**Township Archives
Township of Brick, NJ
401 Chambers Bridge Rd, Brick, NJ 08723**

CONSTRUCTION PERMIT APPLICATION

1. Proposed Work Site at: 861 Glenwood Place, Brick, NJ
 2. Name of Owner in Fee: DRM CONSTRUCTION LLP com
 Tel. (848) 448-6107 e-mail DRMCONSTRUCTIONLLP@GMAIL
 Address 3 MARBIL AVENUE, Toms River 08757
 3. Ownership in Fee: Public _____ Private X (732) 644-4895
 4. Principal Contractor: DRM CONSTRUCTION LLP Tel. (848) 448-6107
 Address _____ e-mail _____
 License No. OR, if new home, Builder Reg. No. 049743 Exp. Date 9/30/2024
 Home Improvement Contractor Registration No. or Exemption Reason _____
 Federal Emp. ID No. 82-2716179 FAX: 214-0493
 5. Architect or Engineer Michel D'Salvo Contact (609) (732) 814-7399
 Address 1471 IROQUOIS COURT, Toms River e-mail MINDSALVO@VERIZON.NET
 Tel. _____ FAX: _____
 6. Responsible Person in Charge once Work has Begun Rafael / Manuel
 Tel. (848) 448-6107 / (732) 644-4895 FAX: _____

Building Subcode & Flood Plain Plan Review		Date: 4/13/23				
Control # C-22-004435		FLOOD HAZARD MAP:				
Address: 861 CLOWOOD PL NW		PFIRM BFE	9'			
Block: 590 Lot: 6		FIRM BFE				
Project NEW SFD		BFE=	DFE= 10'

STAIR DETAIL

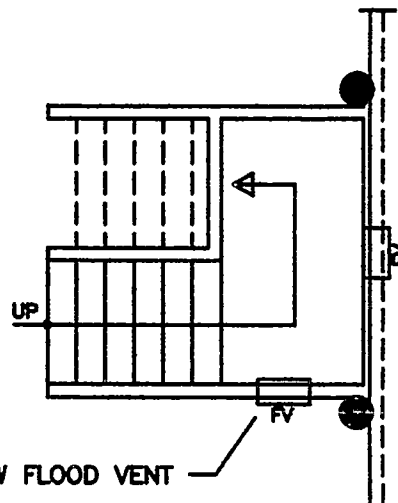
This letter addresses the placement of flood vents. Each enclosed area is required to have (2) flood vents. A flood vent is to be added to the side of the enclosed area under the stair.

STAIR DETAIL

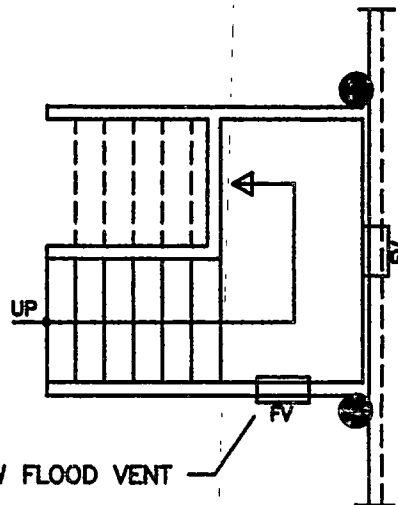
This letter addresses the placement of flood vents. Each enclosed area is required to have (2) flood vents. A flood vent is to be added to the side of the enclosed area under the stair.
